UNITED STATES PATENT AND TRADEMARK OFFICE

10/599,138

Office Action Summary	Application No. 10/599,138	Applicant(s) CHALK, CRAIG JOHN	
	Examiner Rowland D. Do	Art Unit 3677

DETAILED ACTION

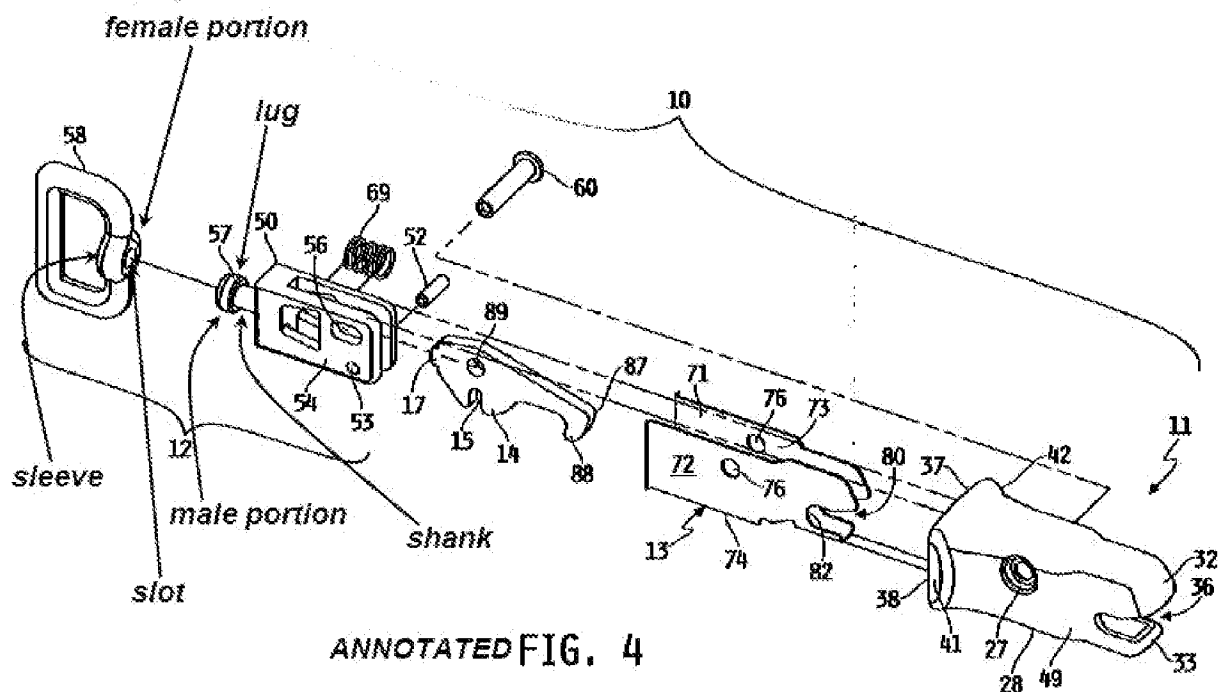
Claims 1, 4-5, and 7-10 are rejected under 35 U.S.C. 102(e) as being anticipated by Anthony ET al. (US PG Pub 2004/0208692).

Regarding claim 1, Anthony et al. disclose an **attachment mechanism** (10) *[for attaching together a pet lead (20) and a clip (14 and 13 combined) for a pet collar], the mechanism comprising a **male portion** (see annotated Fig.4) *[adapted for connection to one of the lead or clip], and a **female portion** (see AF4) *[adapted for connection to the other of the clip or lead respectively], wherein the male portion is a **shank** (see AF4) having a **lug** (see AF4) at a distal end thereof and the female portion is a **sleeve** (see AF4) having a **slot** (see AF4) in a **side wall** thereof (internal within “slot” shown in AF4) that is shaped to laterally receive the shank and lug therethrough and allow the lug to move longitudinally to a **seat** (surface inside “slot” abutting the “shank” and “lug”, see Figs.3-4), from where it must be moved longitudinally then laterally to be removed from the sleeve (see [0027]).

Regarding claim 4, Anthony discloses the male portion is integrally formed with and extends from a proximal end of the clip (see AF4), *[and the female portion is adapted for connection to a distal end of the lead].

Regarding claim 10, Anthony discloses the latching means is a lever arm (14) pivotally mounted in the intermediate ends to a remainder of the clip (see Fig.4 and Fig.10), with one end of the lever arm defining a protruding ear (41) of the animal shape for manual engagement by a user (see [0036]), and the other end of the lever arm defining a jaw portion (36) of the animal shape that can move to open a mouth portion of the animal shape and into which a loop of a shackle or ring can be located (see Fig.10).
